SUBJECT: **Addendum Number 2**
RCTDA Railwalk Covered Drive
228 East Kerr Street, Salisbury, NC

FROM: Ramsay Burgin Smith Architects, Inc.
225 North Main Street - Suite 501
Salisbury, NC 28144

RCTDA RAILWALK COVERED DRIVE

ADDENDUM No.2
BULLETIN DRAWING

DETAILS SHOWING EXPANSION JOINTS IN CONCRETE SIDEWALK

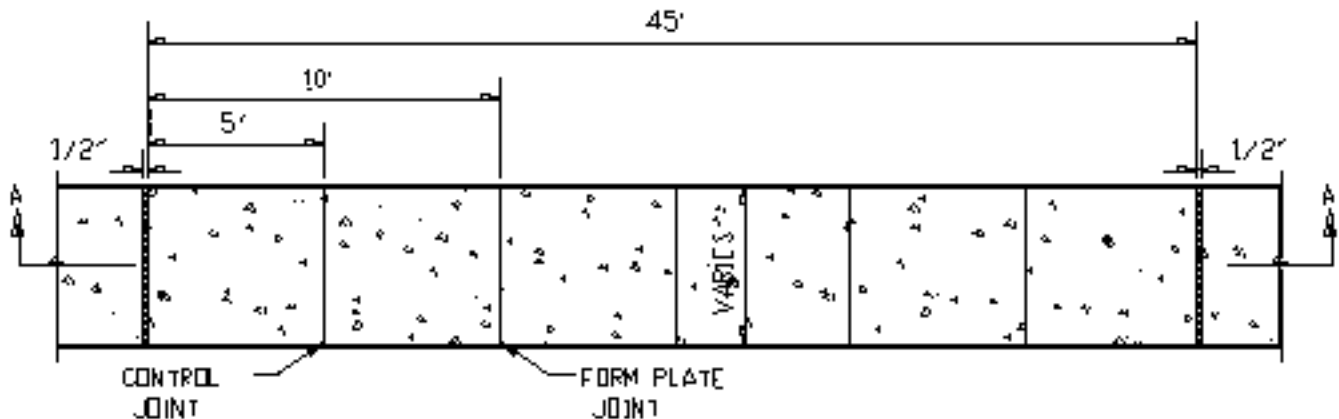
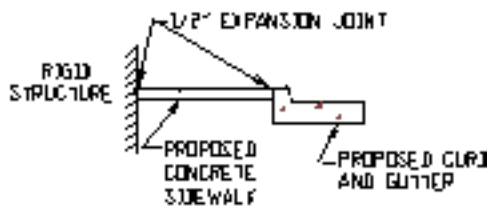
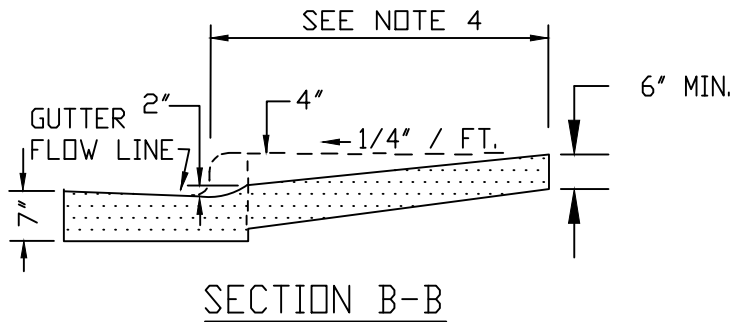
Item 3 - New Sidewalk – Reference A1, S1.1, S2.1

Construction of new footings below the existing façade will require the removal and replacement of the existing sidewalk. See the attached sidewalk bulletin drawing for specifications and details required by the City of Salisbury, NC.

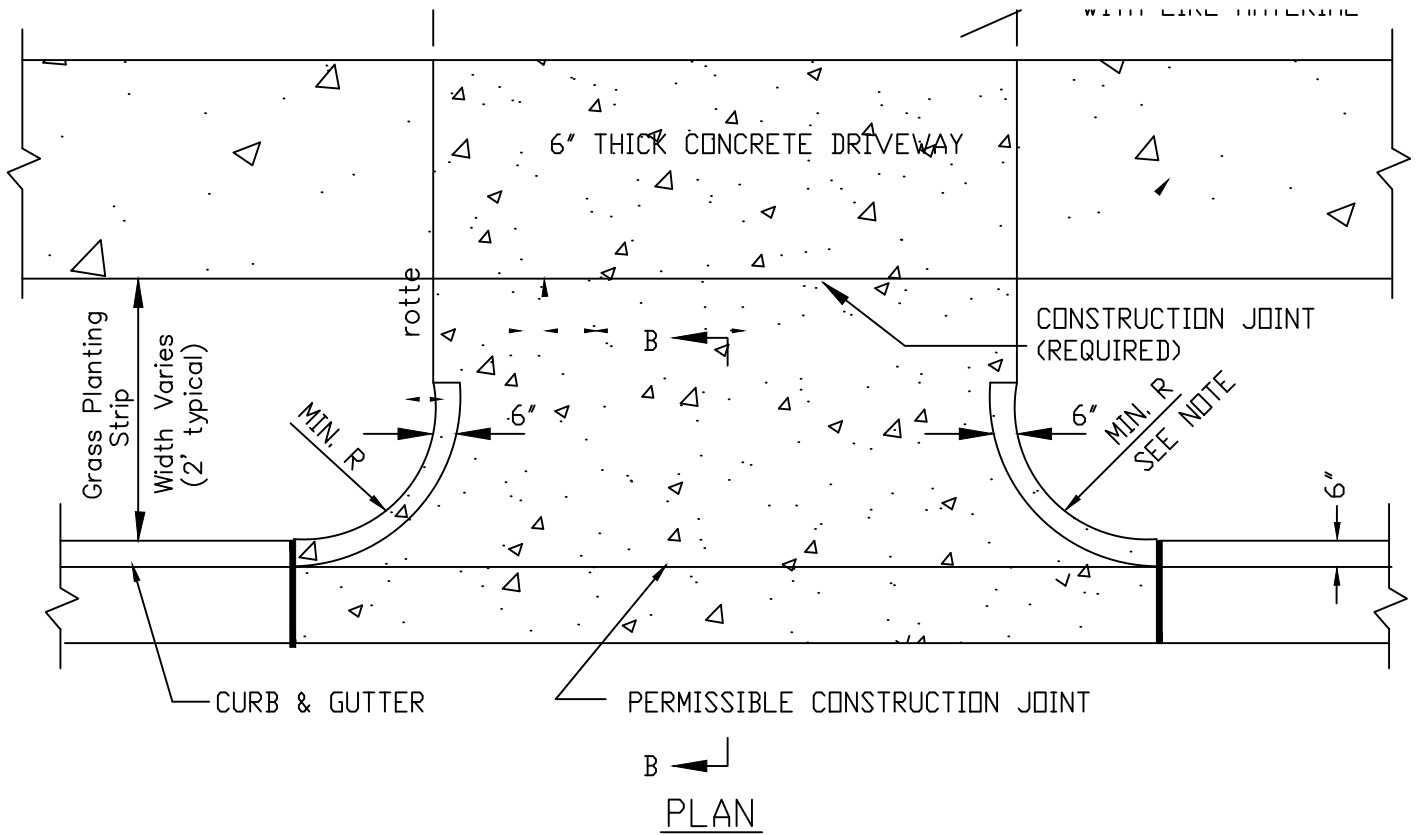
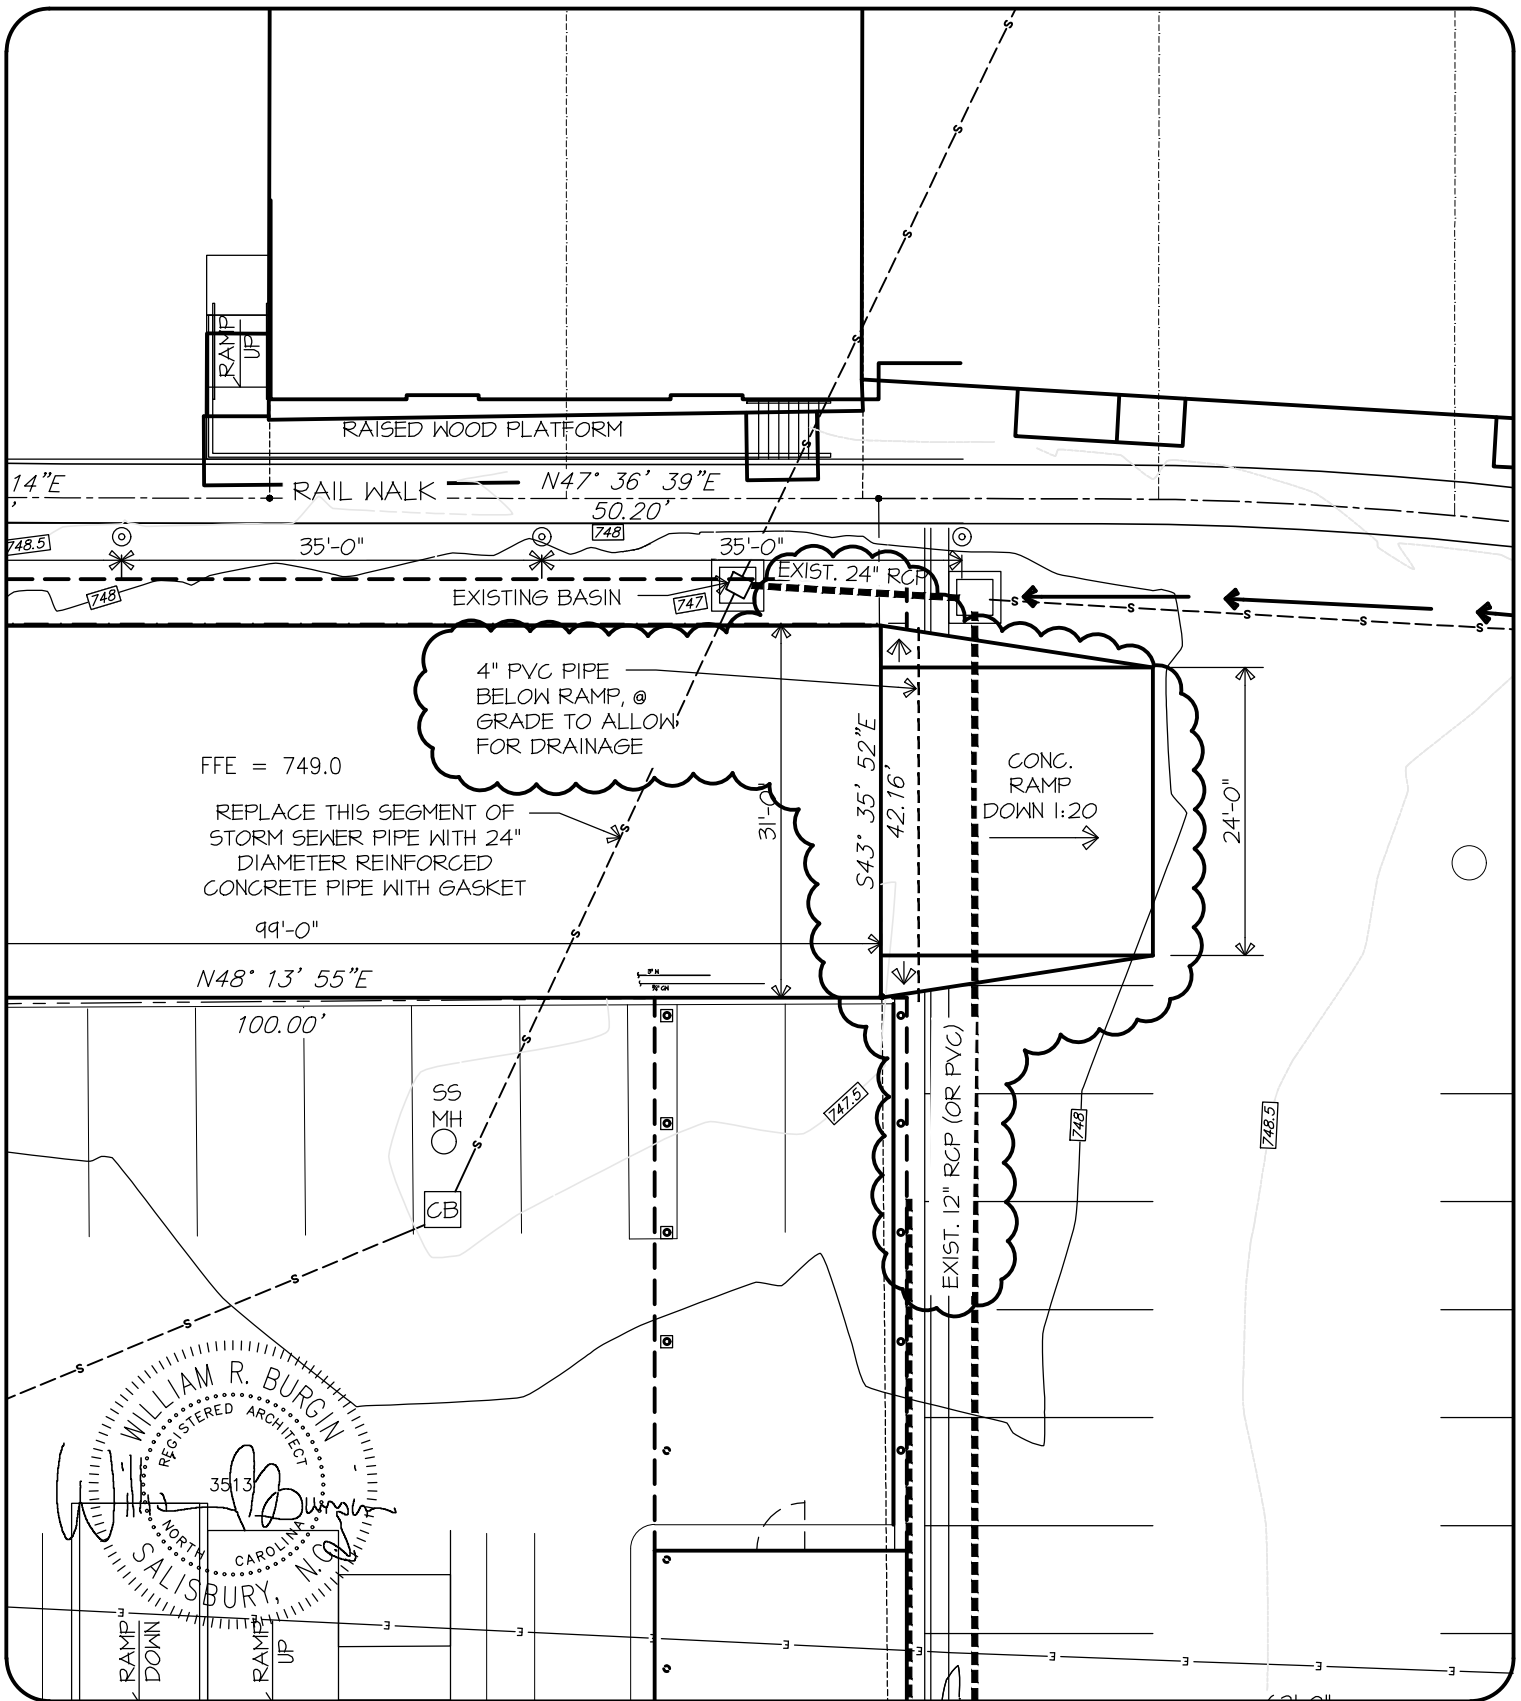
Item 4 - New Driveway – Reference A1

Construction of new stamped concrete driveway will require new curb and gutter and 5 ft. radius on either edge. See the attached driveway bulletin drawing for specifications and details required by the City of Salisbury, NC.

VI-BO-14/RB

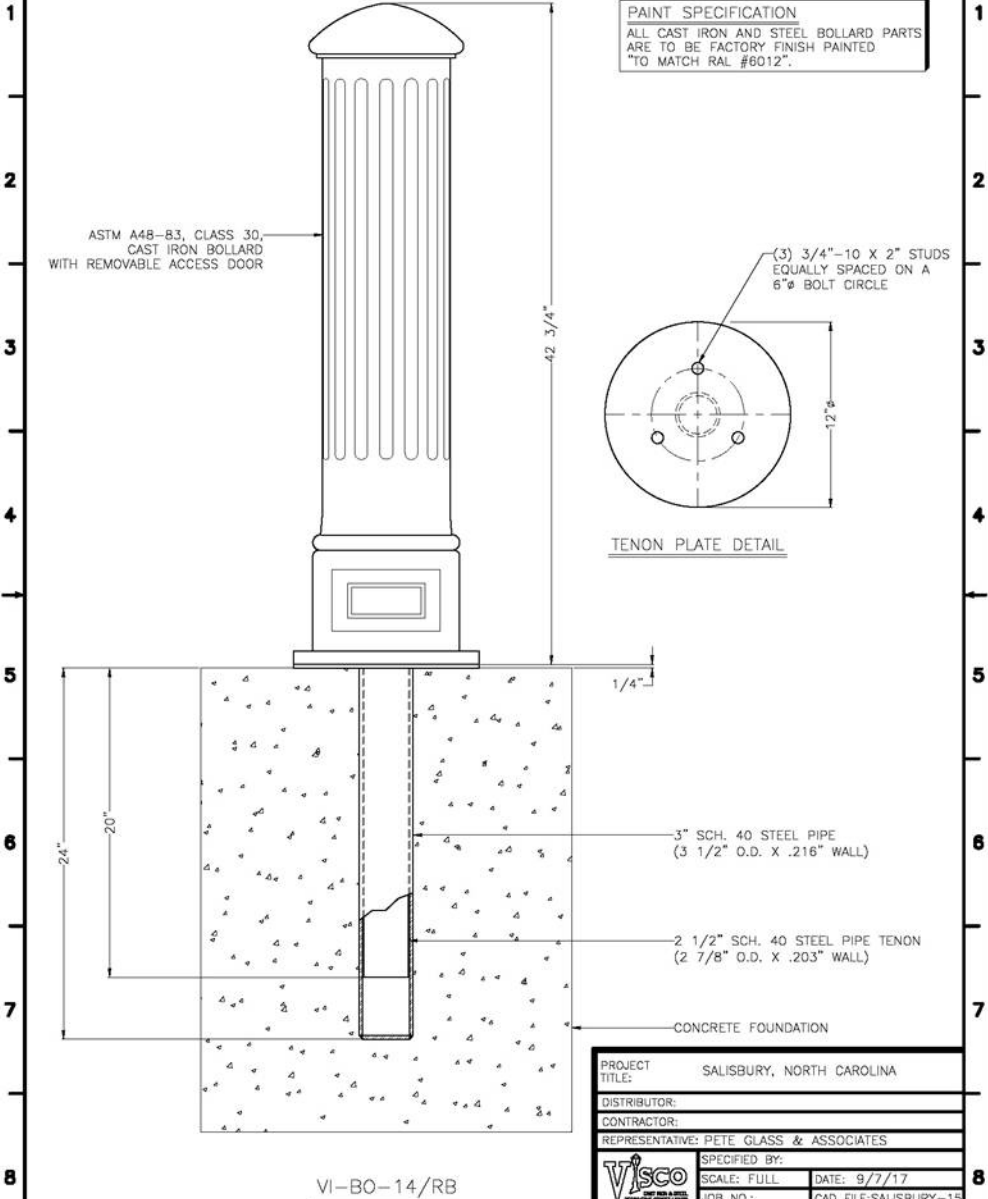
Item 7 - Bollard Information – Reference A2

Drawing A2 shows 6 bollards needed for this project. See the attached bollard detail for specifications on the bollard required (or approved equal).
